Rebuttal Report of Christian R. Petrich

In the Matter of Application for Transfer No. 73811 (Shekinah Industries); Application for Transfer No. 73834 (Orchard Ranch); Application for Permit No. 63-32499 (Mayfield Townsite); Application for Permit No. 61-12095 (Nevid-Corder); Application for Permit No. 61-12096 (Nevid); Application for Permit No. 63-32703 (Orchard Ranch); Application for Permit No. 61-12256 (Intermountain Sewer & Water); Application for Permit No. 63-33344 (ARK Properties-Mayfield Townsite) before the Idaho Department of Water Resources

January 30, 2013

Figure 12. Snake River minimum flows.

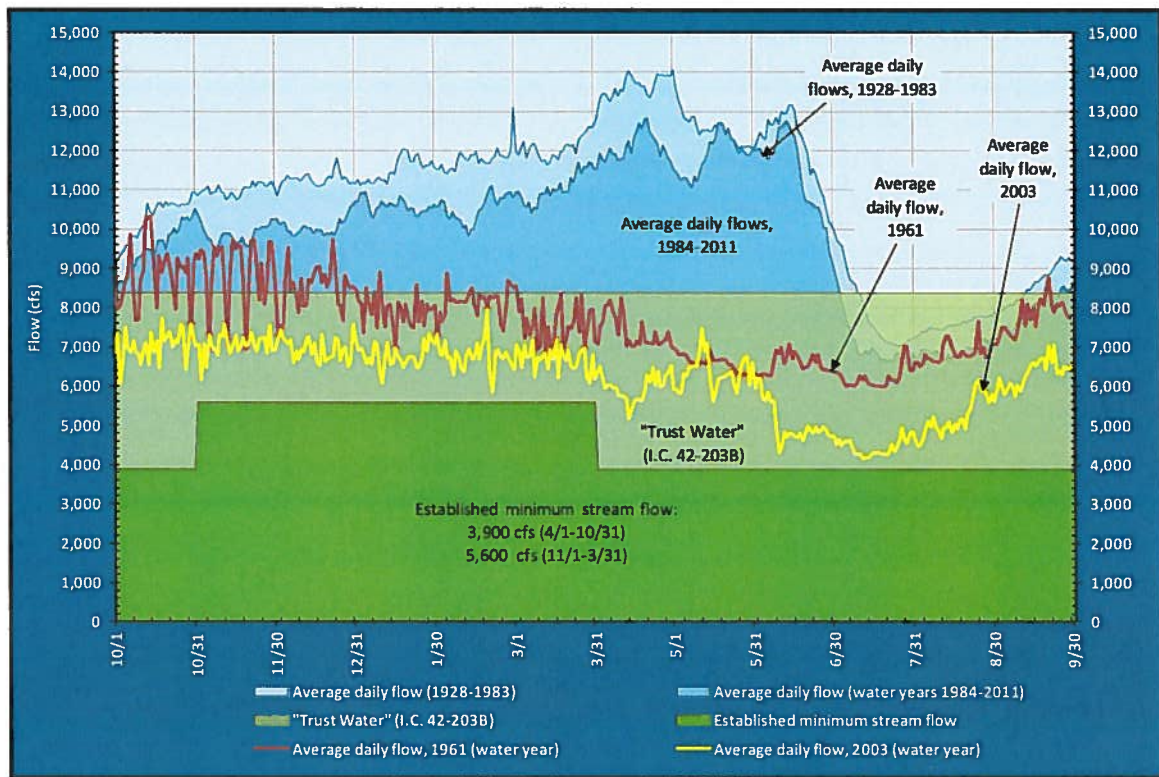
It is important to recognize that average Snake River flows remain well above established minimums. Average daily flows since 1984 (Figure 12) have not only been greater than established minimum flows, but during substantial portions of the year have been greater than the 8,400-cfs generating capacity at Swan Falls Dam. Approval of consolidated-case applications and transfers would represent absolutely no impact to hydroelectric generation during times of the flows greater than 8,400 cfs.

Recent low-flow years (e.g. 2003 – see Figure 12) have seen average daily flows less than 8,400 cfs (but more than minimum flows). However, hydropower rights

Based on the hydrographs in Figure 12, it appears unlikely that a future dip below established minimum flows, if it occurs, would have a long duration. Non-approval of the proposed consolidated-case applications and transfers because Snake River flows may dip below established minimums for a short period of time sometime in the future would preclude the full economic development of the study-area groundwater resource as provided under Idaho Code § 42-226. Furthermore, attempting to prevent a dip in minimum flows by disapproval of these consolidated applications and transfers would be futile because of the relatively small amount of water involved¹⁴.
